February 23, 2024

**Re: Peer review opinion of the Planning Justification Report and Revised Urban Design Report submitted as part of an Official Plan and Zoning By-law Amendment application OR 09/23 for the lands at 134 and 144 Fountain Street North, 199 Abraham Street and 102 Fountain Street South in Cambridge**

Figure 1: Proposed and recently-approved development applications for tall and mid-rise buildings in the area of the proposed development.

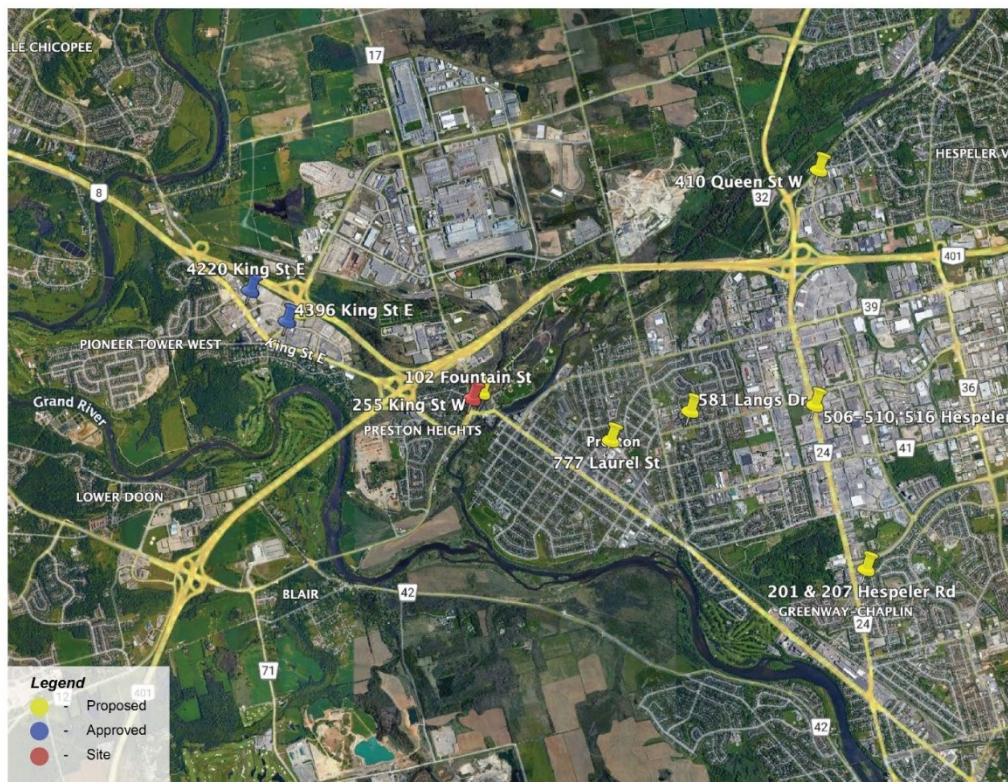
This review of the development context finds that there are several sites where significant residential intensification is proposed in Cambridge and south-east Kitchener. Most proposals are located in areas of large-scale retail, commercial, and mixed-use centres, significantly distant from the proposed development. There is one proposal nearby, at 255 King Street West, which has similar adjacencies to lower-scale neighbourhoods as the proposed development, and proposes heights of 15 and 17 storeys.

- The proposal is significantly taller than the current neighbouring development application, and any existing buildings nearby. (see figure 1)
  - The proposal site is located within a 6-7min walking radius of the potential future ION Preston Station
